Re: Albuquerque ER & Hospital
4315 Wyoming Blvd. NE
Traffic Circulation Layout
Engineer's Stamp 11-09-21 (G19-D004D)

Re: Albuquerque ER & Hospital
4315 Wyoming Blvd. NE
Traffic Circulation Layout
Engineer's Stamp 10-12-21 (G19-D004D)

**RE: ALBUQUERQUE ER & HOSPITAL
4315 WYOMING BLVD NE
TRAFFIC CIRCULATION LAYOUT**

TRAFFIC CIRCULATION
LAYOUT

SP-1

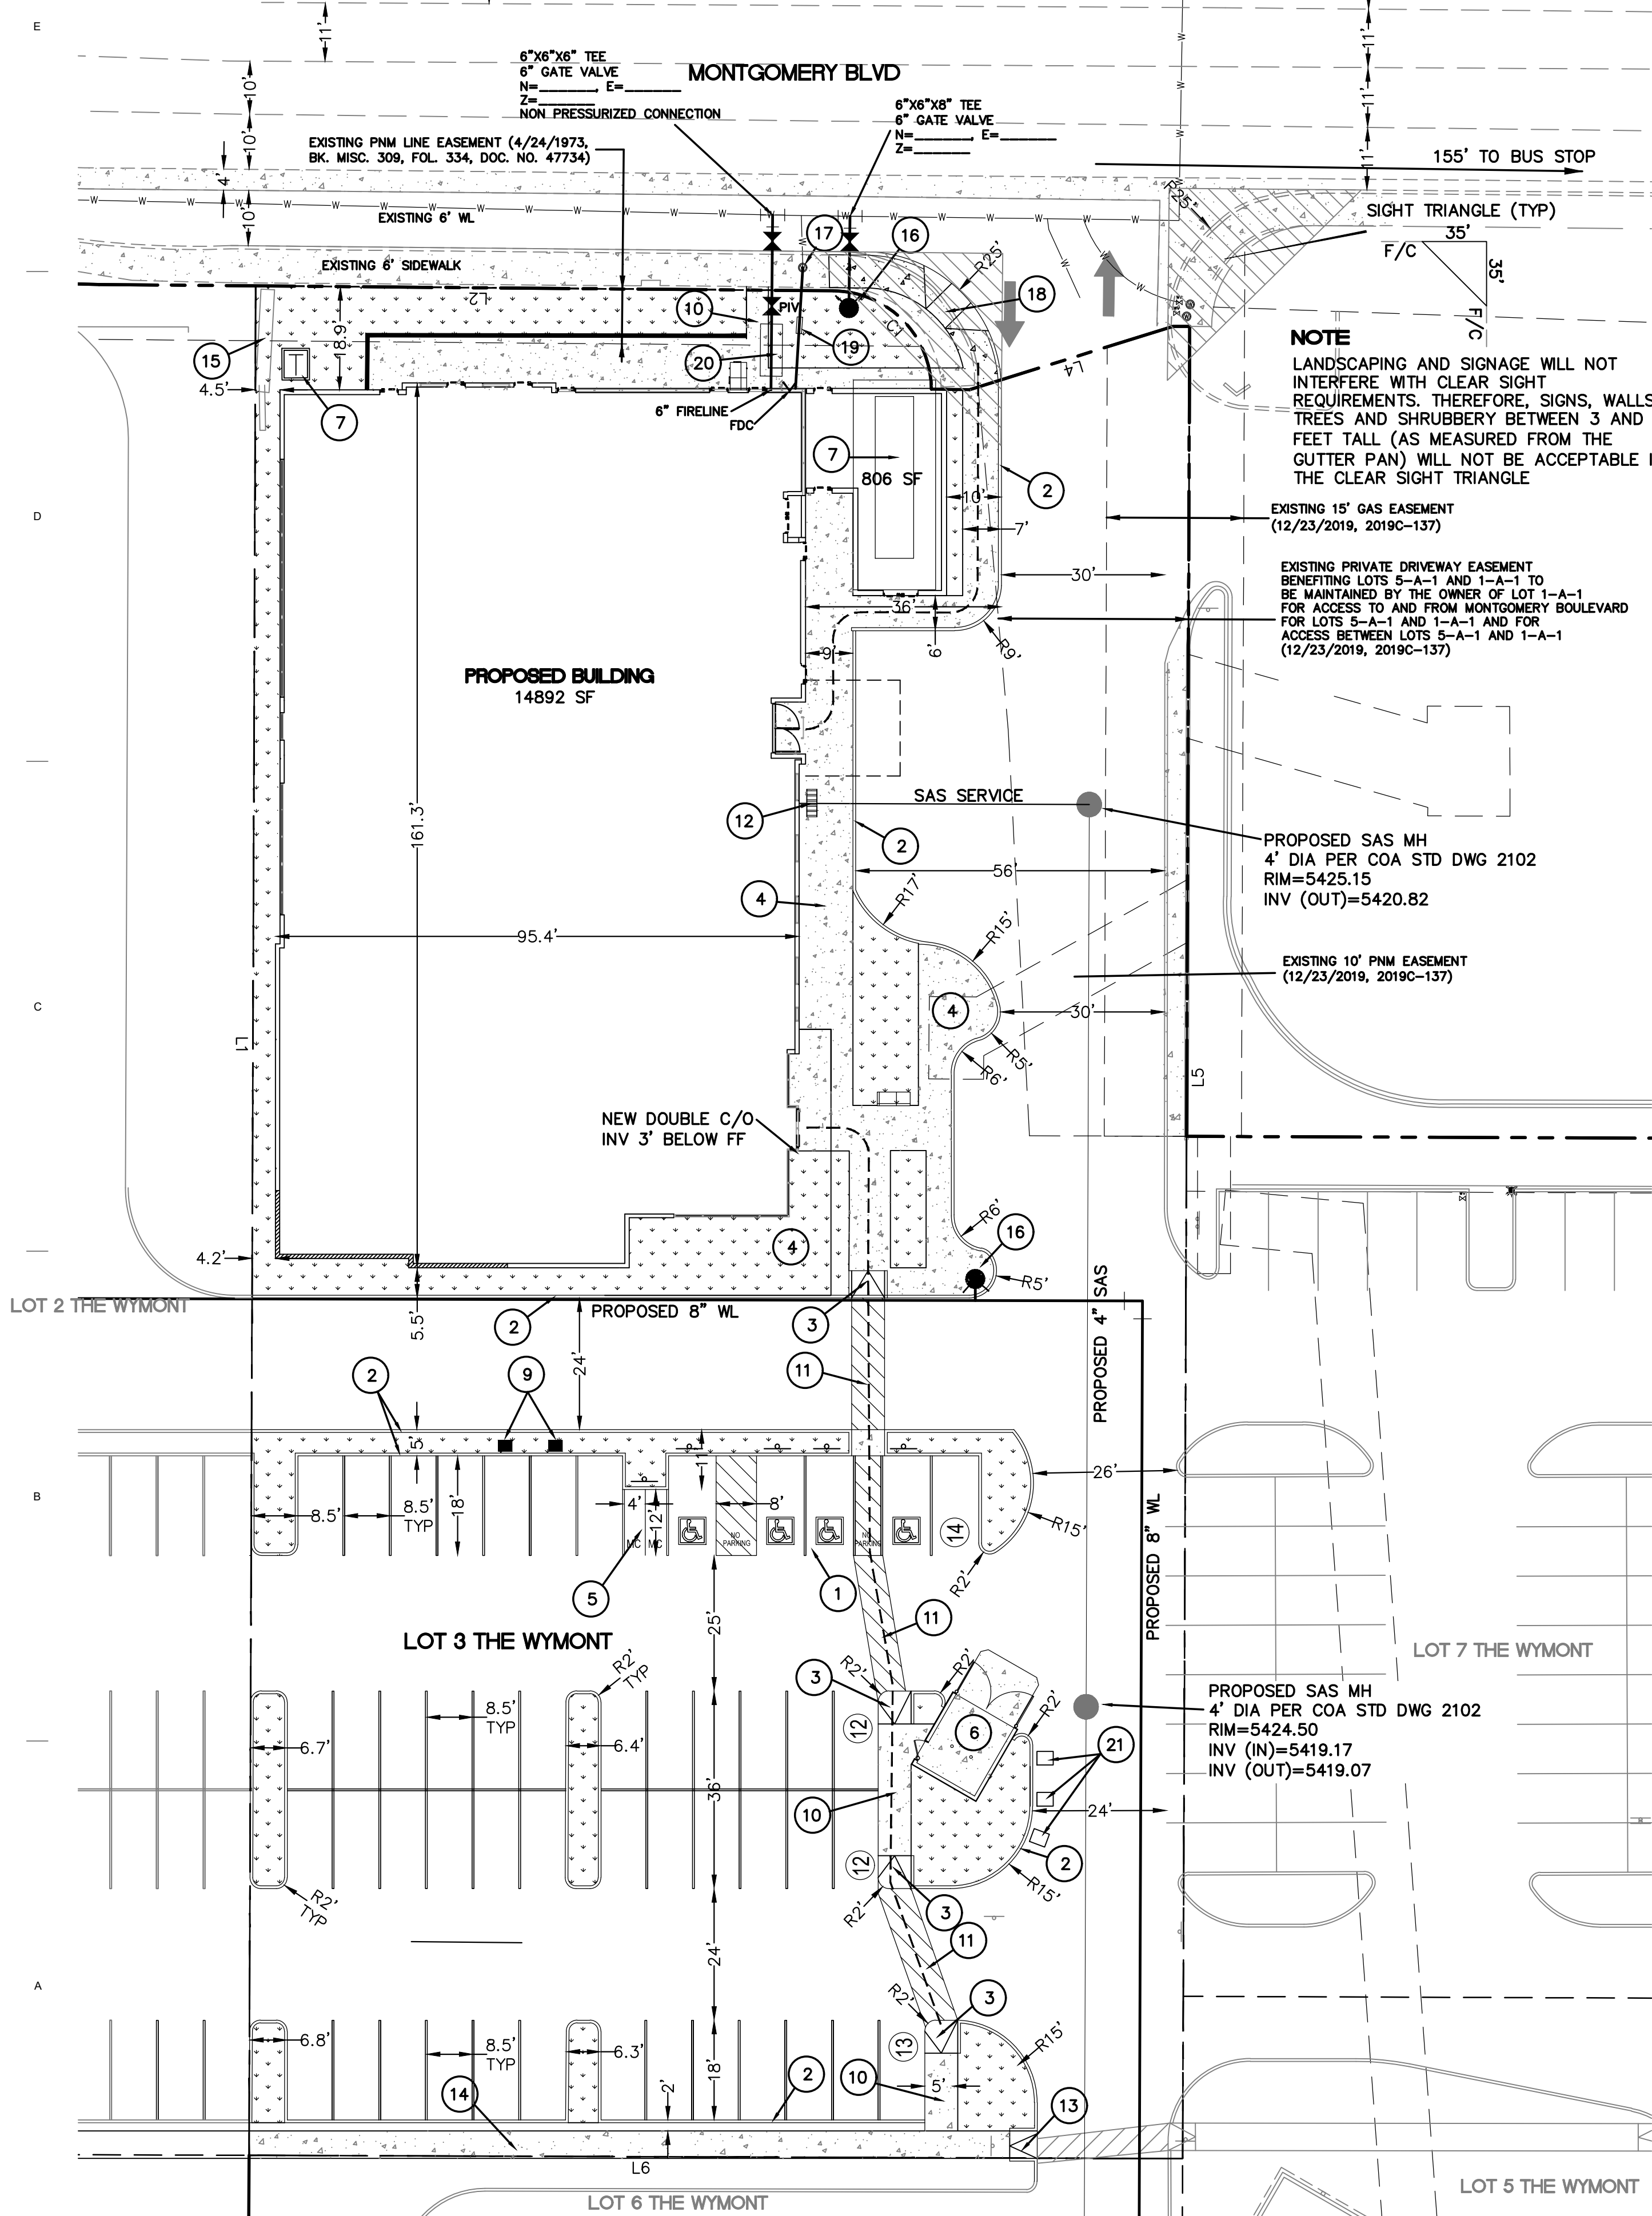
1. Key note 18: Proposed driveway access Ramp on-site plan is not per COA standard DWG. Please modify the site plan.
2. Site plan showing that ADA Van access aisle is 8', but the details sheet shows 7'. Please address this concern.
3. The ADA accessible spaces must include an access aisle. Van accessible aisles should be 8ft wide; all others should be 5ft wide.
4. ADA Van accessible aisle: Per DPM, a 6 ft. wide ADA accessible pedestrian pathway is required from the ADA parking stall access aisles to the building entrances. Please clearly show this pathway and provide details.
5. ADA Parking space: It appears there will be a conflict between the overhang vehicle and the proposed ADA sign. Please address this concern.
6. Provide Fire Marshal Approval.
7. Provide a copy of Approved Preliminary Plat. (This is a condition for approving TCL)

15. Bicycle parking spaces shall be at least 6feet long and 2feet wide.
This detail is shown on Sheet SP-2.
16. Per the IDO, a 6ft. wide ADA accessible pedestrian pathway is required from the public sidewalk to the building entrances. Please clearly show this pathway and provide details.
The ADA pathway is now shown on Sheet SP-1 as a heavy dashed line. Details are shown on Sheet SP-2.

17. Per DPM, a 6ft. wide ADA accessible pedestrian pathway is required from the ADA parking stall access aisles to the building entrances. Please clearly show this pathway and provide details.
The ADA pathway is now shown on Sheet SP-1 as a heavy dashed line. Details are shown on Sheet SP-2.

28. Please add a note on the plan stating "All improvements located in the Right of Way must be included on the work order."
This note was added to Sheet SP-1.

29. Add a note stating "All broken or cracked sidewalk must be replaced with sidewalk and curb & gutter." A build note must be provided referring to the appropriate City Standard drawing.
This note was added to Sheet SP-1.

1. ALL BROKEN AND CRACKED SIDEWALK MUST BE REPLACED WITH NEW SIDEWALK, CURB AND GUTTER PER COA STD DWG 2430 AND 2415A
2. ALL IMPROVEMENTS LOCATED IN THE CITY ROW SHALL BE COMPLETED BY WORK ORDER

SHEET NUMBER
SP-3

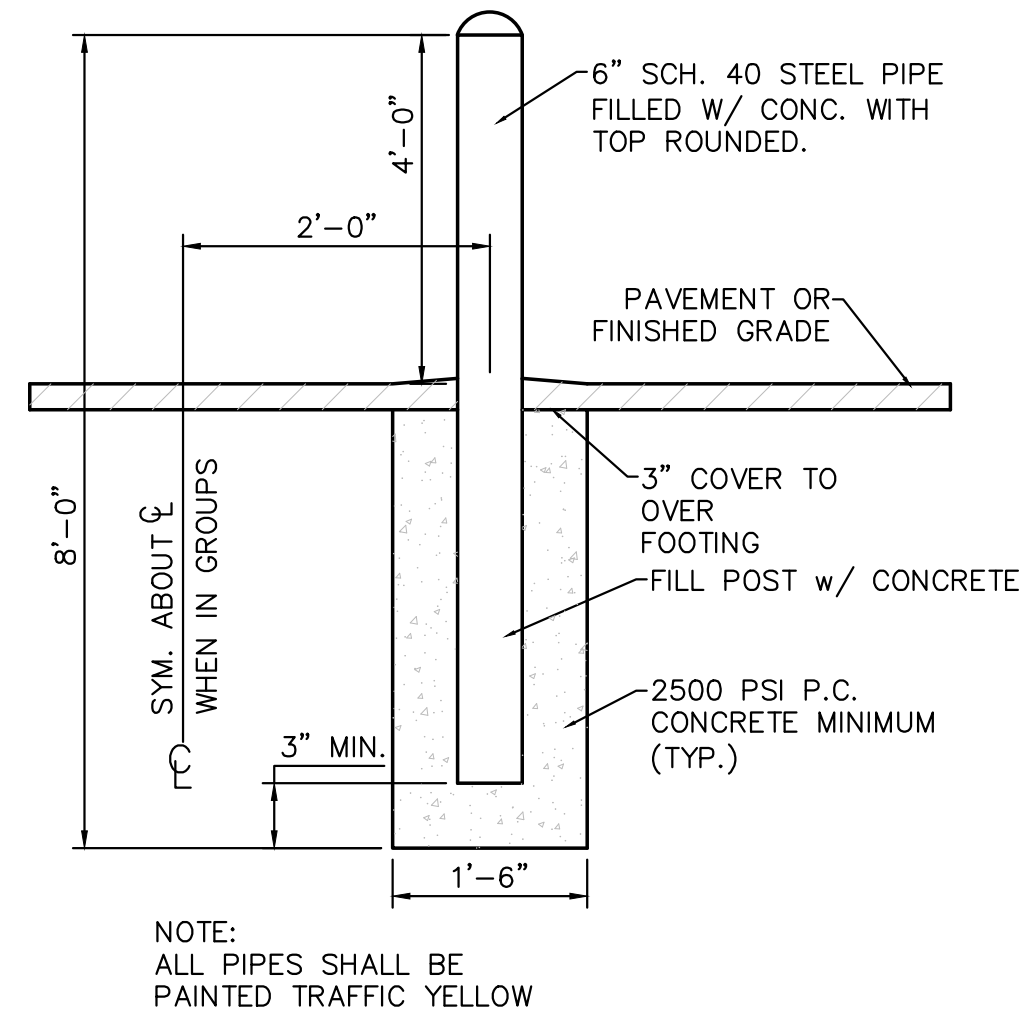
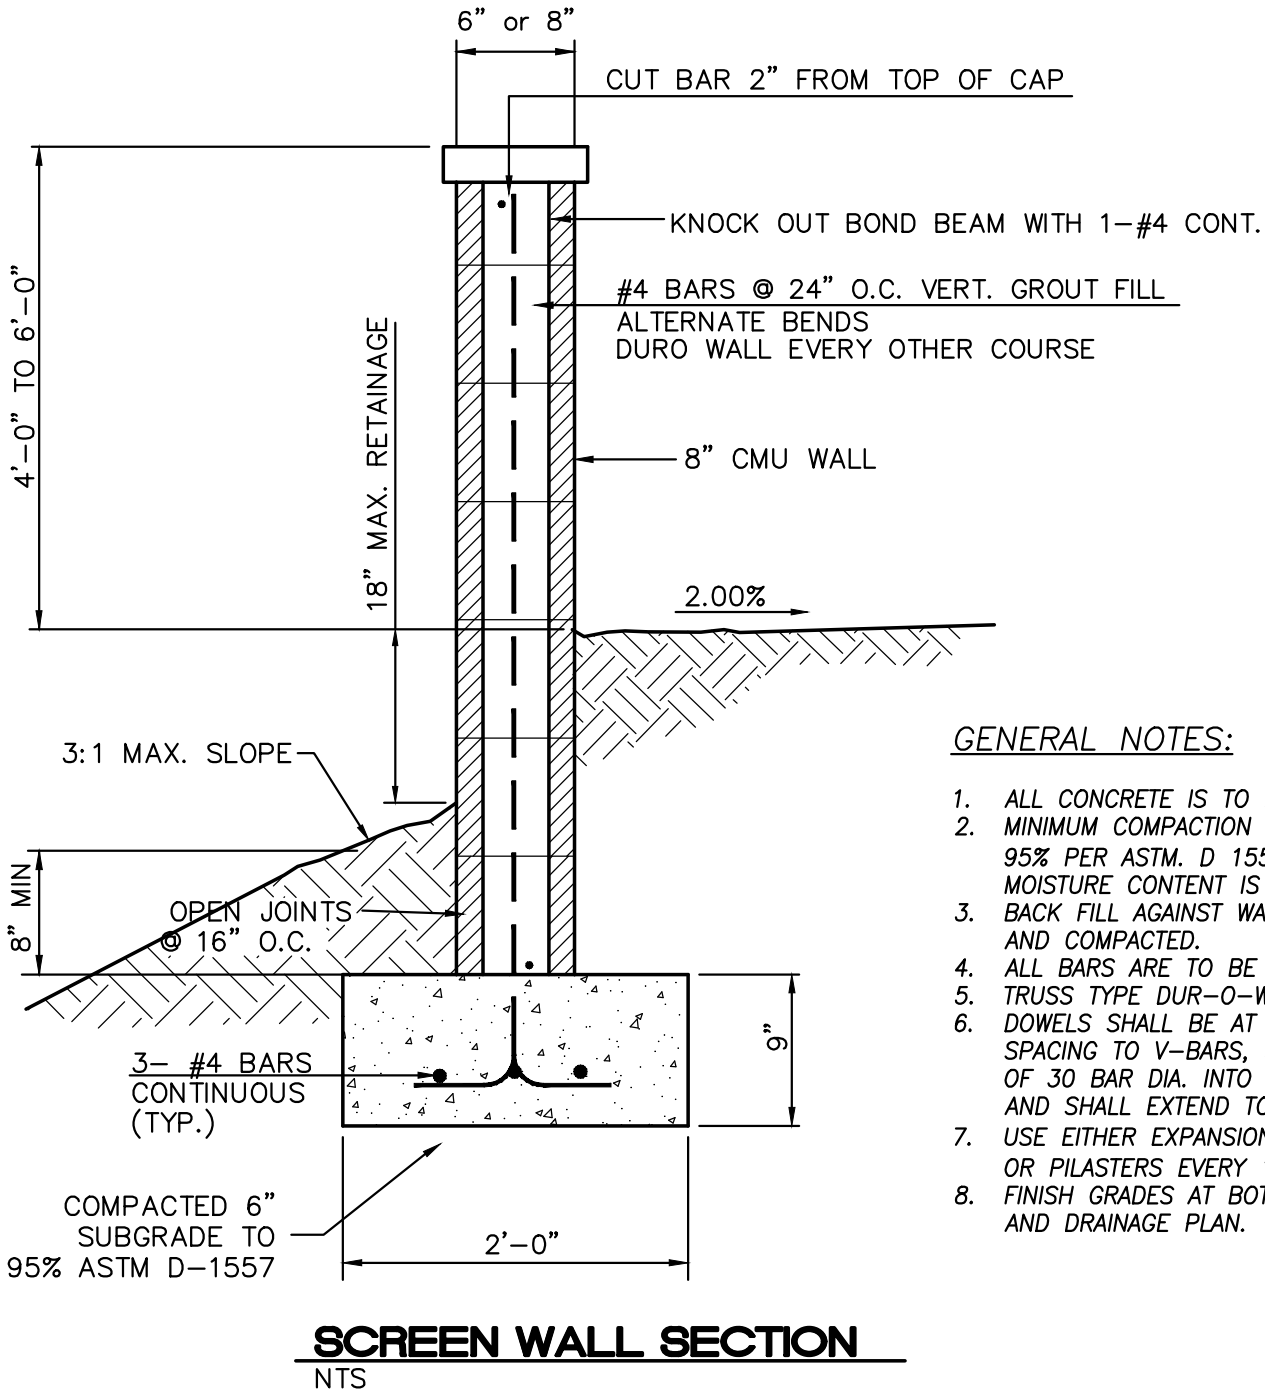
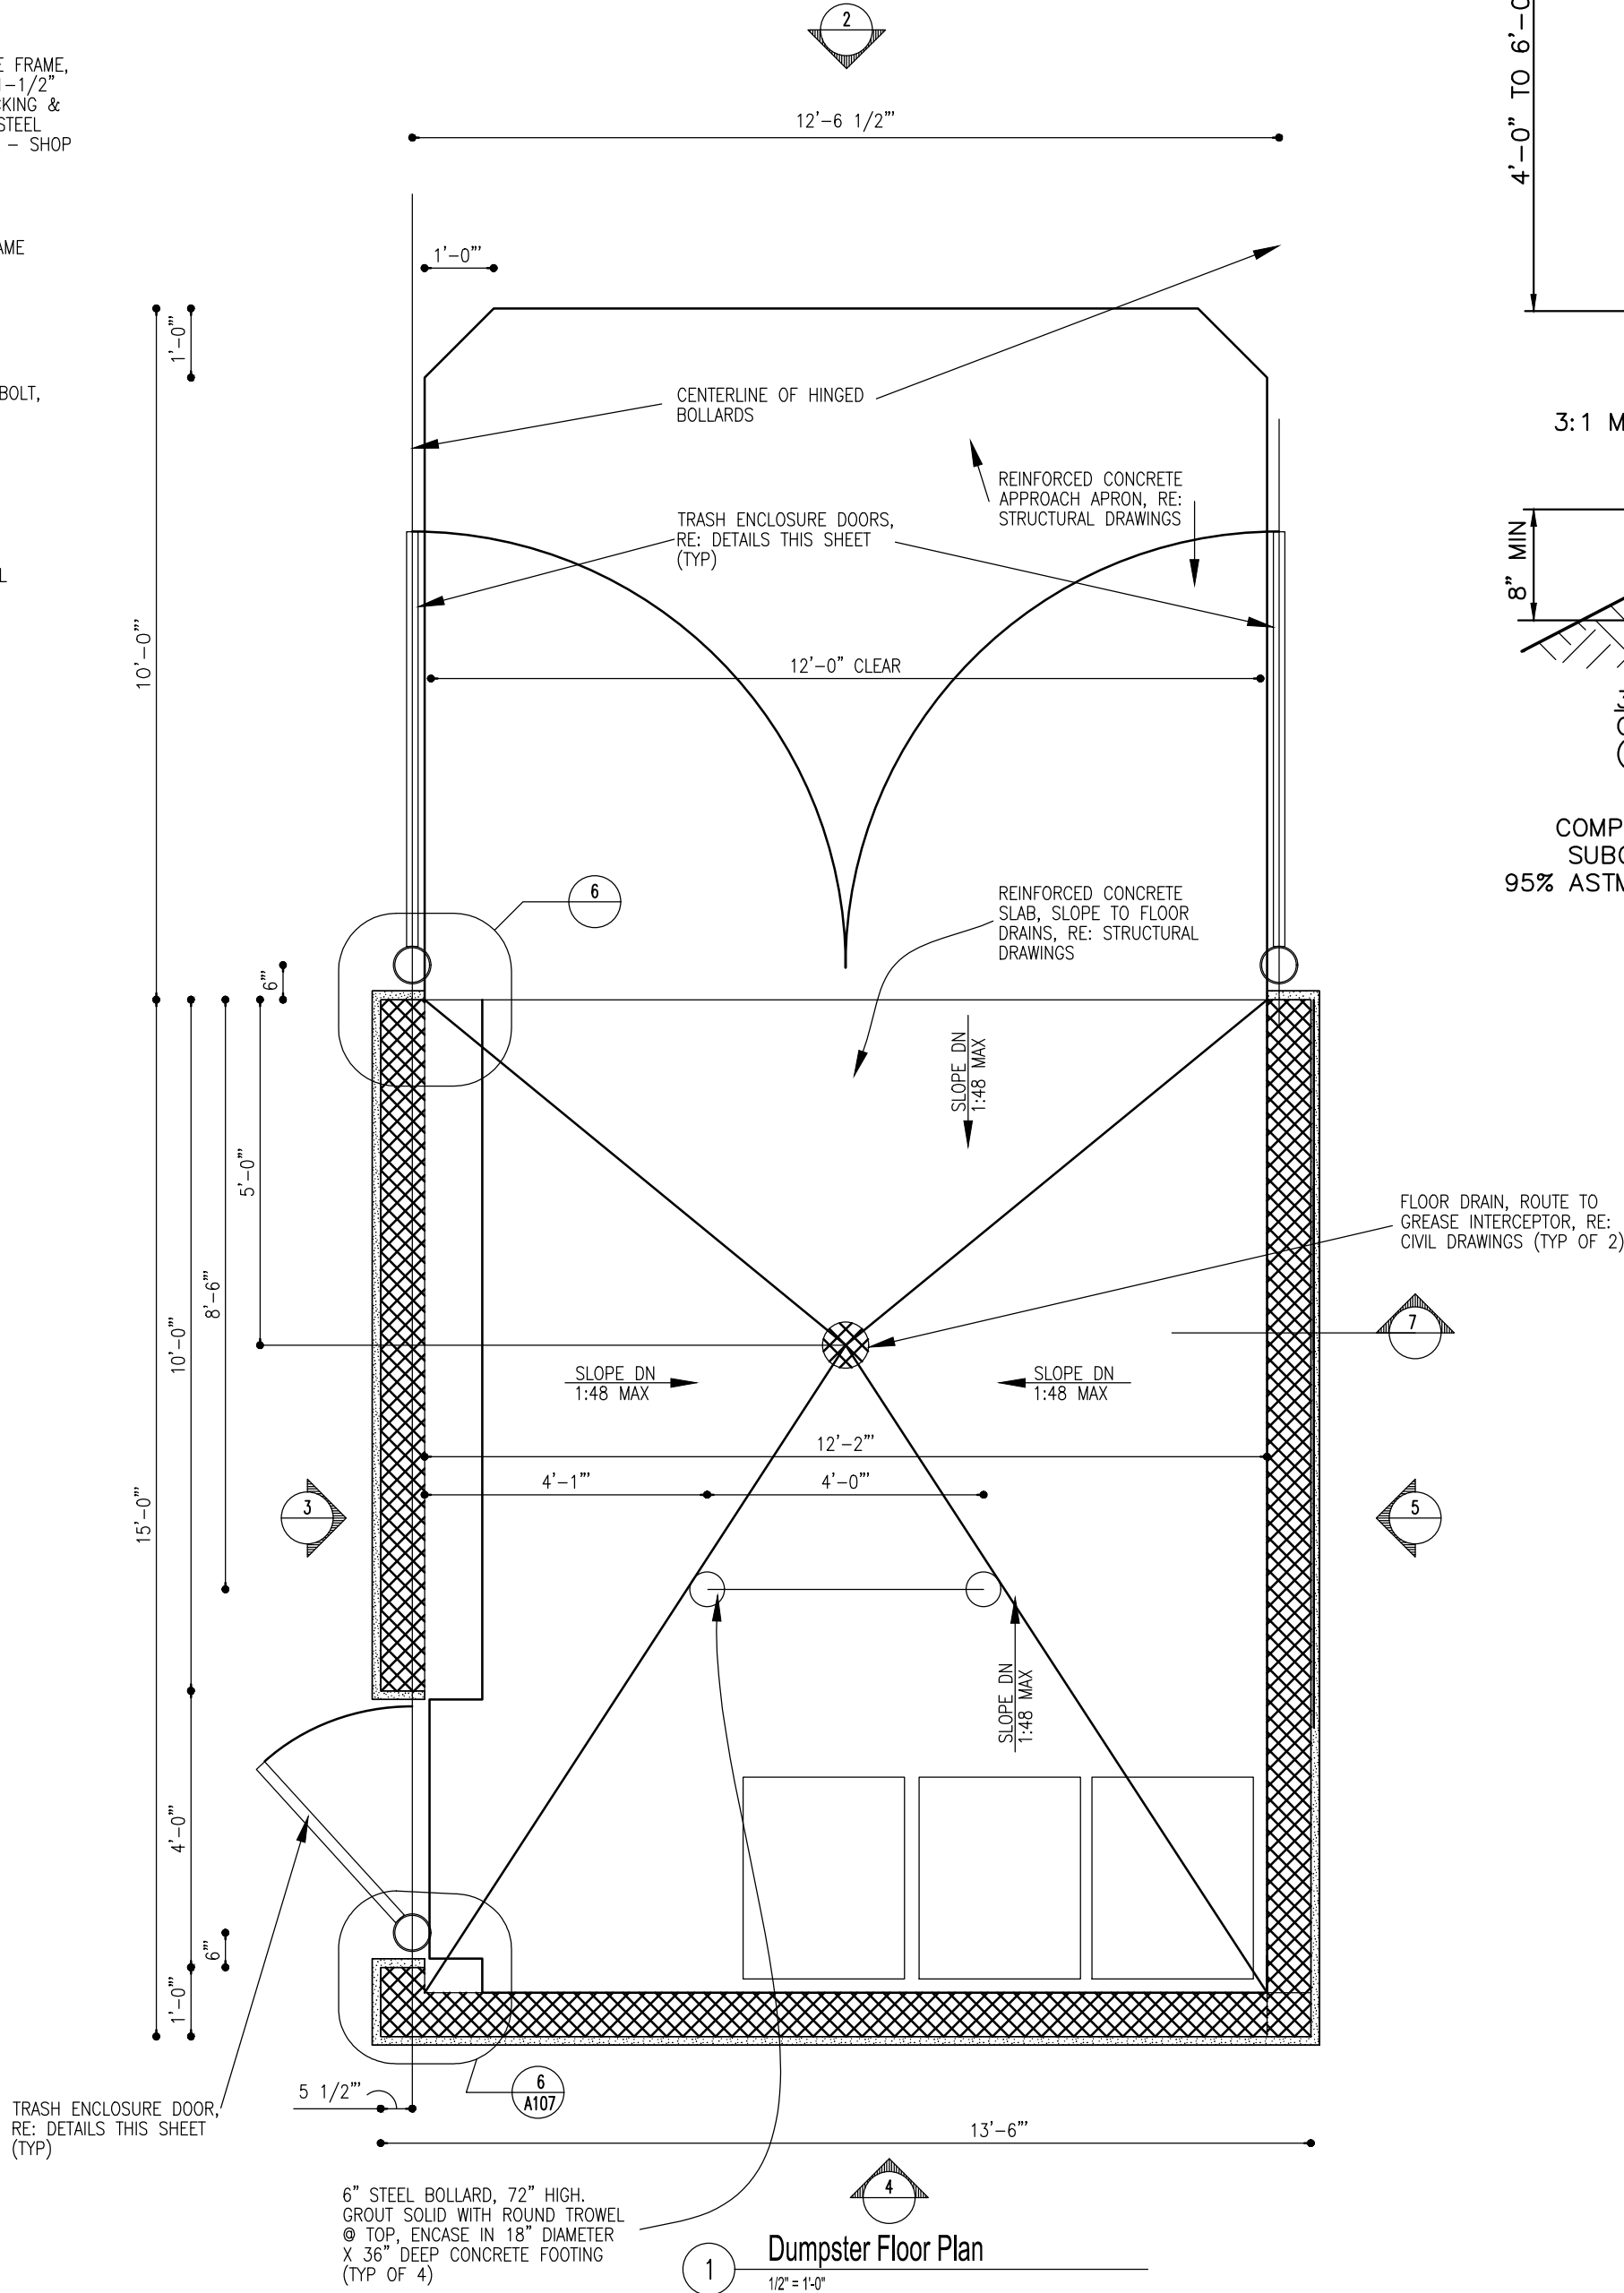
2. Keyed Note 1, 3, 12, 13, & 18: Details' sheet is missing. Provide details for each infrastructure, reference COA standard DWG.

9. The ADA accessible spaces must include as access aisle. Van accessible aisles should be 8ft wide; all others should be 5ft wide.

10. The ADA accessible parking sign must have the required language per 66-7-352.4C NMSA 1978
"Violations Are Subject to a Fine and/or Towing." Please call out detail and location of signs.
The sign detail is shown on Sheet SP-2

11. Motorcycle parking spaces shall be designated by its own conspicuously posted upright sign, either free-standing or wall mounted per the zoning code.
The sign detail is shown on Sheet SP-2.

COA Standard Drawings are referenced where applicable. Sheet SP-2 is now included showing all of the details.

The aisles are dimensioned accordingly and shown in a detail on Sheet SP-2.
